EASTONVILLE ROAD FROM LONDONDERRY DRIVE TO REX ROAD SEGMENT 1 IMPROVEMENTS STATIONING 14+19.69 - 47+66.51

OVERALL SHEET INDEX	
SEGMENT 1	SHEETS 1-42
SEGMENT 2	SHEETS 43-96

EDARP FILING NO. CDR2321

SHEET
 PD.3
 20

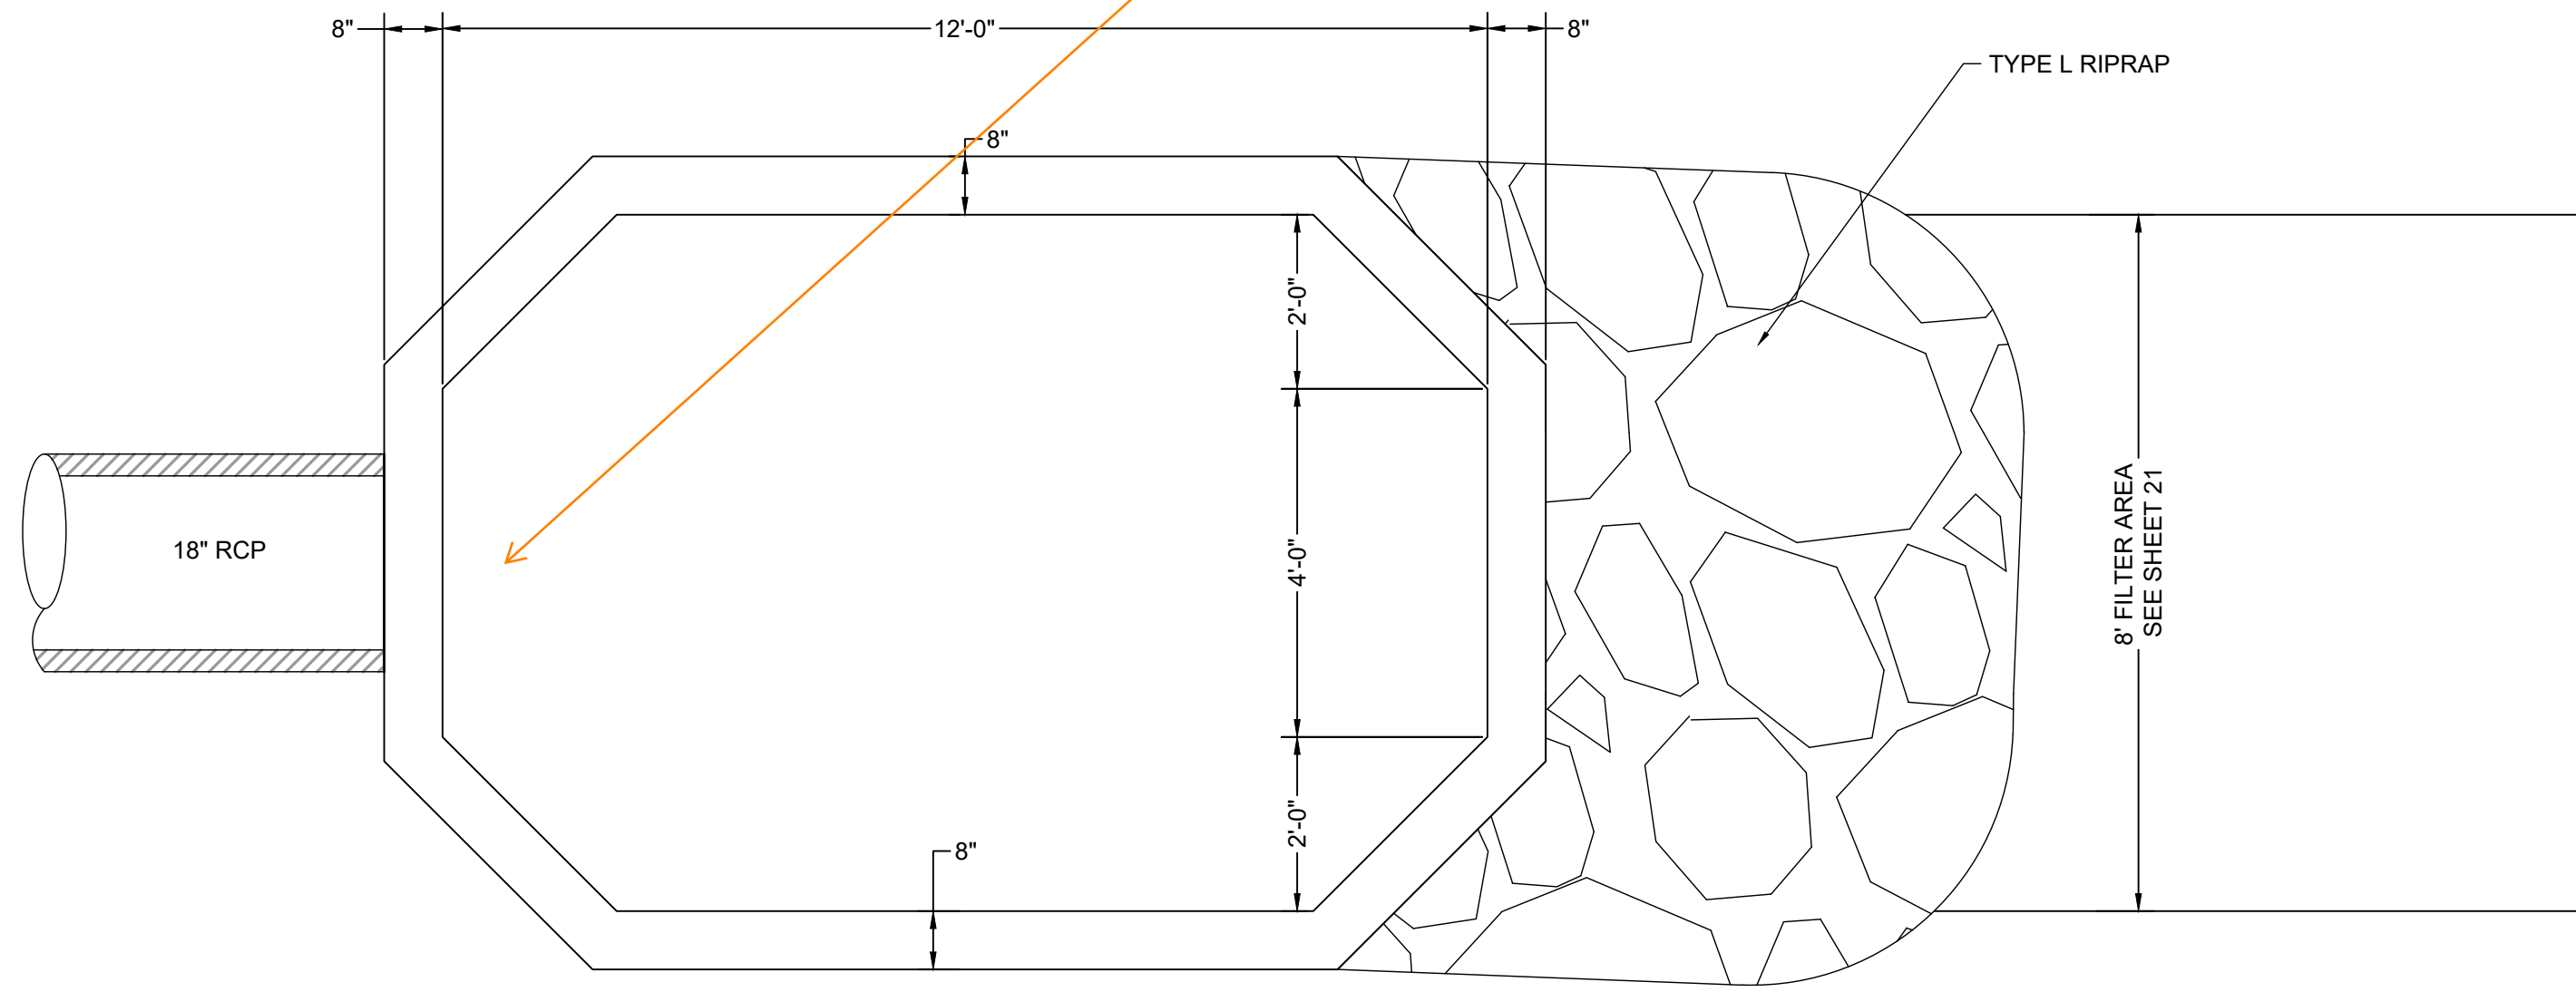
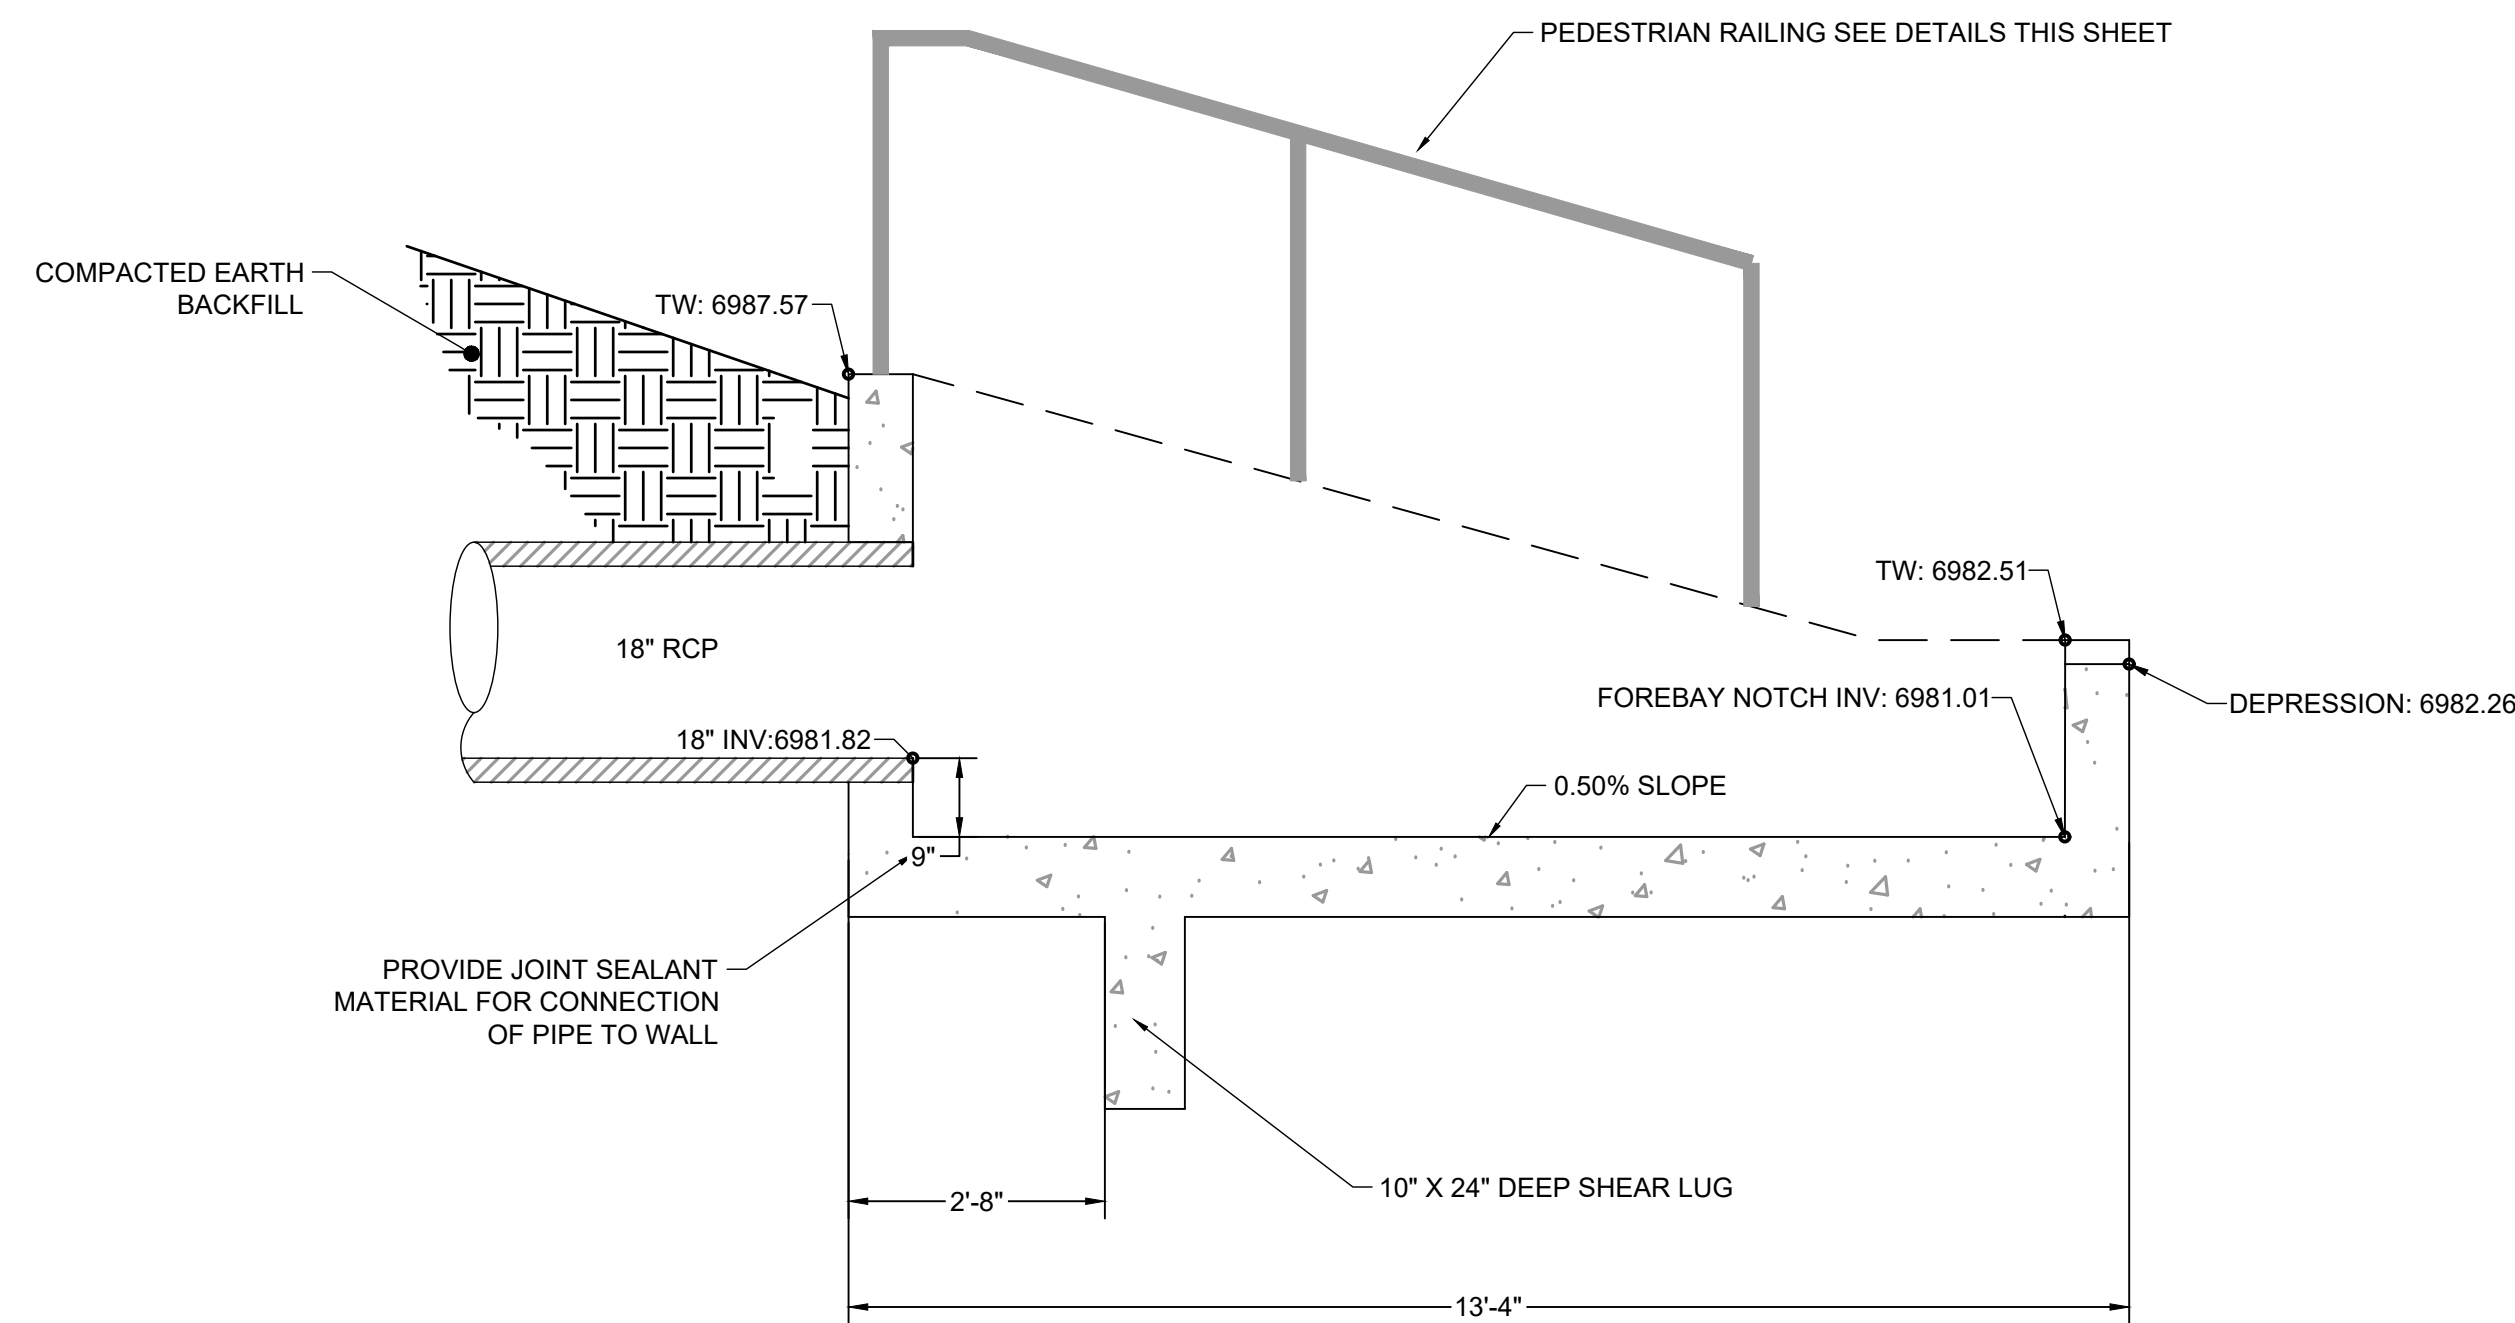
Provide forebay sizing calcs in the FDR.

SHEET
PD.12 29

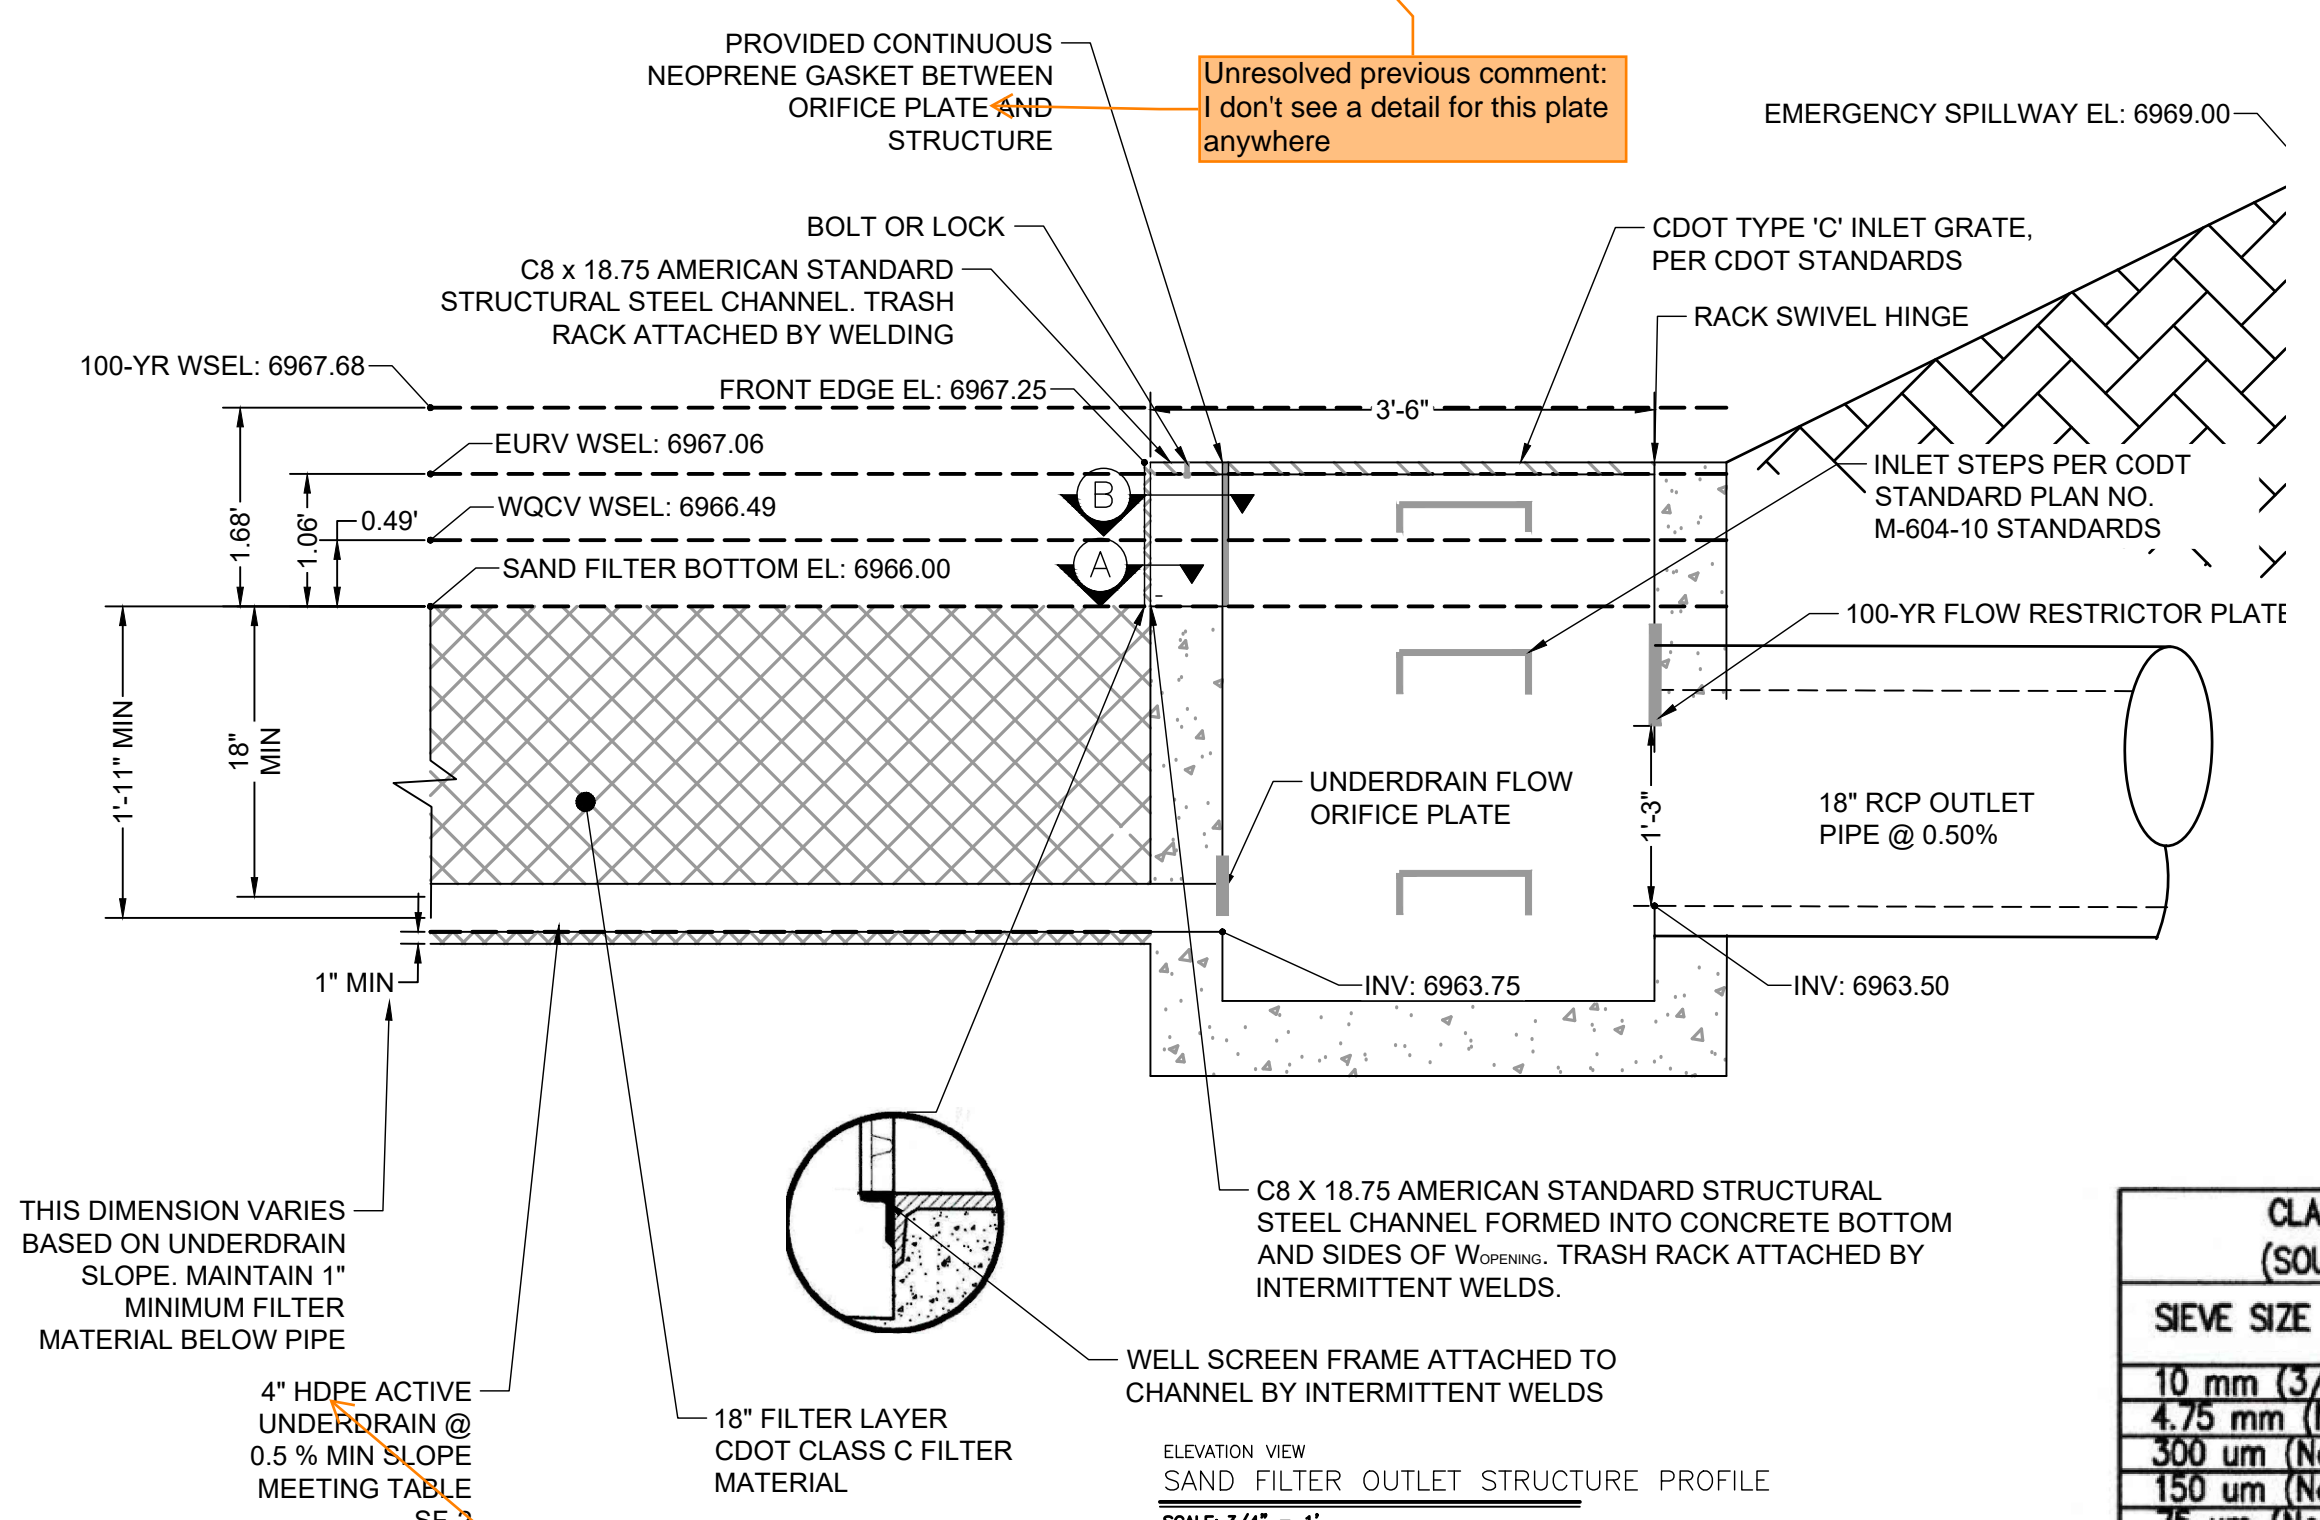
Provide forebay sizing calcs in the FDR.
 Details for this forebay are missing from this sheet (like up close plan view of forebay with dimensions)
